## **Dynergy Morro Bay, LLC Final Prevention of Significant Deterioration Permit**

### **Fact Sheet**

Morro Bay Power Plant Modernization Project  
US EPA Response to Comments  
Proposed Prevention of Significant Deterioration Air Permit

Figure 1

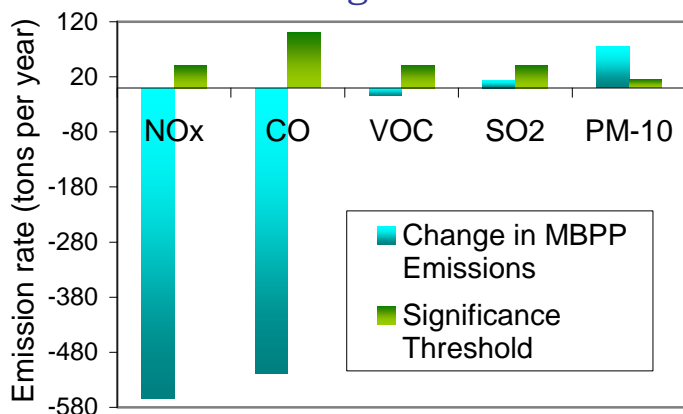
- Power generation will increase from 1002 MW to 1200 MW
- Decreased emissions of NO<sub>x</sub>, CO, and VOC (Figure 1)
- Emissions increase of SO<sub>2</sub> below significance threshold (Figure 1)
- Emissions increase of PM-10 (Figure 1) triggers PSD review and requirements

Figure 2

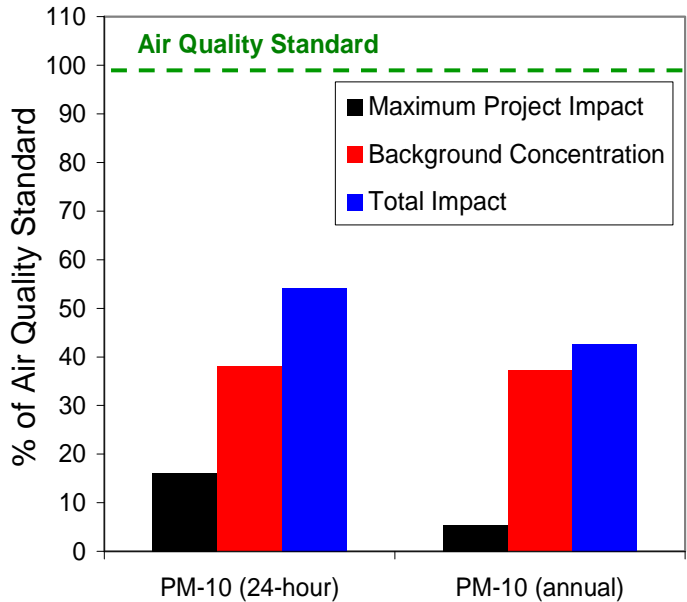
- Impact of PM-10 emissions (Figure 2) modeled using new emissions level and 145-foot stack heights
- Emissions of PM-10 will not result in ambient PM-10 concentrations that exceed the National Ambient Air Quality Standards (NAAQS)
- The incremental increase in PM-10 concentration (24-hour and annual average), complies with the allowable PSD Increment
- At the San Rafael Wilderness (Class I area), the incremental increase in PM-10 concentration (24-hour and annual average), complies with the allowable PSD Class I Increment
- Emissions will not significantly impact visibility, soils, or vegetation
